Delegated Report

2024/2397/P

7 Burghley Road
London
NW5 1UD

Erection of roof extension with Juliet balcony to rear and installation of rooflights to front and rear roof slopes, erection of two-storey part width rear extension at lower and upper ground floor, installation of French doors and balcony at rear upper ground floor with external access steps to lower ground floor.

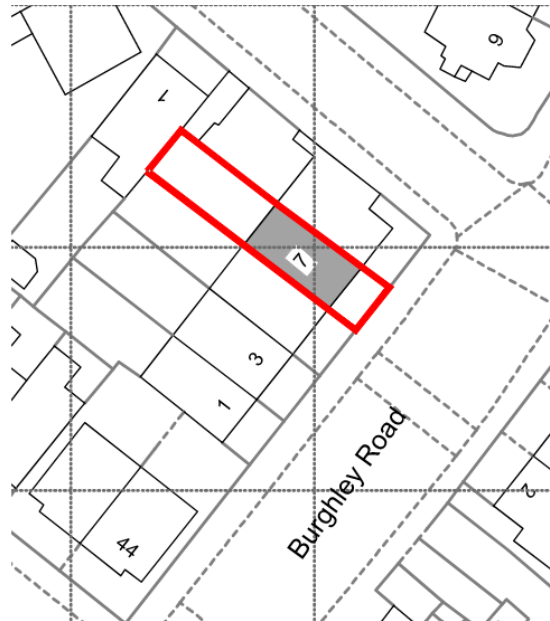
4.5. The proposed rear extension would comprise of a two-storey half width extension to a height of 6m overall at the boundary with number 7A Burghley Road. It would be formed of two elements: a lower ground floor extension measuring approximately 2.5m wide and 2.5m deep; and an upper ground floor level extension approximately 2.5m wide and 1.5m deep. The upper ground floor extension would feature a large oriel window to the rear elevation and glazing to the side and roof, both levels would have full height glazing to the side elevation facing towards no.5, and a clerestory window to the rear lower ground floor level. The cill would be lowered to the rear upper ground floor window to form French doors, and a bi-fold or sliding door would replace the window at lower ground floor level.

4.6. While the terrace is not designated as a heritage asset, the terrace retains much of its original design. There are no existing extensions to the rear of the terrace (and no such extensions that have been granted permission, built or otherwise), apart from a small glazed extension at no. 7A Burghley Road which appears to be historic. This is located at its boundary to Evangelist Road, has little visibility, and no impact on neighbours.

4.7. The proposed rear extension is disproportionate in size to the existing building and would dominate the rear elevation due to its height. The upper element of the extension would appear unsympathetic and detract from the form, proportions, and character of the original house. The non-traditional full height glazing and oriel window at upper floor level would emphasise the contemporary design, placing it at odds with traditional fenestration. While the

4.8. The proposed two-storey extension would interrupt the terrace, which is characterised by the uniformity of its rear building line. As there are no direct comparable examples within the terrace, the proposal is not in keeping with the neighbouring established pattern of development, including the ratio of built to unbuilt space. The site location plan shows the largely unimpaired rear building line (see below).

4.10. Any subsequent application should minimise the scale and visibility by reducing the height of the rear extension. There may be scope for a lower ground floor extension, subject to detailed design, that sits beneath boundary walls and allows connection to the rear garden.
